# Index 641-020 Concrete CCTV Pole

**COMMENTARY**

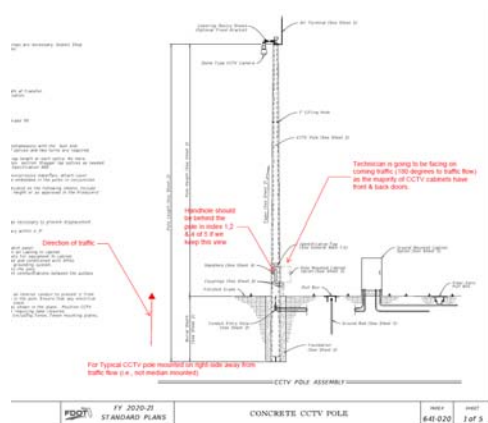
Sheet 5: Deleted the "Pole Plate With Stainless Steel Band" and Added new "Cabinet Adapter Bracket" shown in DETAIL "D" and the POLE MOUNTED CABINET detail.

The following subarticle will be added in the January 2021 SSRBC:  
 "676-2.5.9 Adapter Bracket: If shown in the plans, provide an adapter bracket for pole mounted cabinets that is slotted or otherwise designed to allow banding straps to be installed to avoid pole handholes."

Standard Index 641-020 will also reference the adapter bracket.
